CCL Ref: 15077-070225-edgley

7 May 2025

**Proposed Private Plan Application: The Hills  
Response to Request for Further Information**

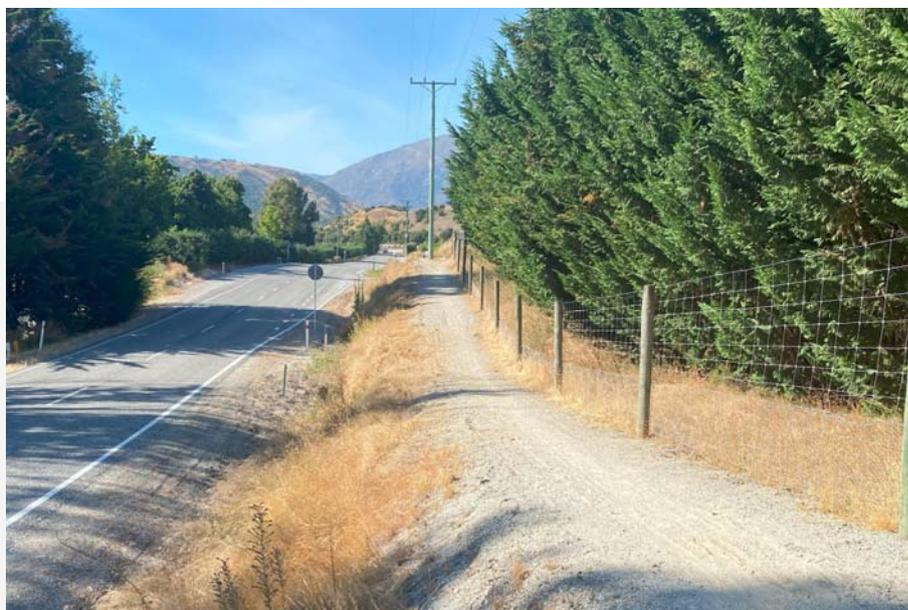
***Matter 18: Please identify any adverse effects on the Trail users experience and whether the existing indicative entry point onto McDonnell Road is more appropriate from both a safety perspective and a user experience perspective***

We are unable to comment on the 'experience' of a Trail user, but we note that an email from the Queenstown Trails Trust dated 7 February 2025 set out that in their opinion, the user experience was better under the proposed trail entry point to McDonnell Road location, as compared with the entry point shown on the operative zone Structure Plan.

We have visited the location of the operative and proposed trail entry points to McDonnell Road and note that both locations are very similar. Importantly, both connect onto an existing gravelled walkway that in parts is elevated above the level of the adjacent roadway.

In our view, the only material differences between the operative and proposed entry points are firstly, that in the immediate vicinity of the proposed entry point is a powerpole which serves to split the existing walkway in two, with each side having a lesser width, and secondly, that the existing walkway is elevated to a greater extent at the proposed trail entry point than in the operative entry point location.

Overall, in our view we do not consider that either location has inherent safety advantages over the other, subject to the matters noted above being resolved through an appropriate scheme design.
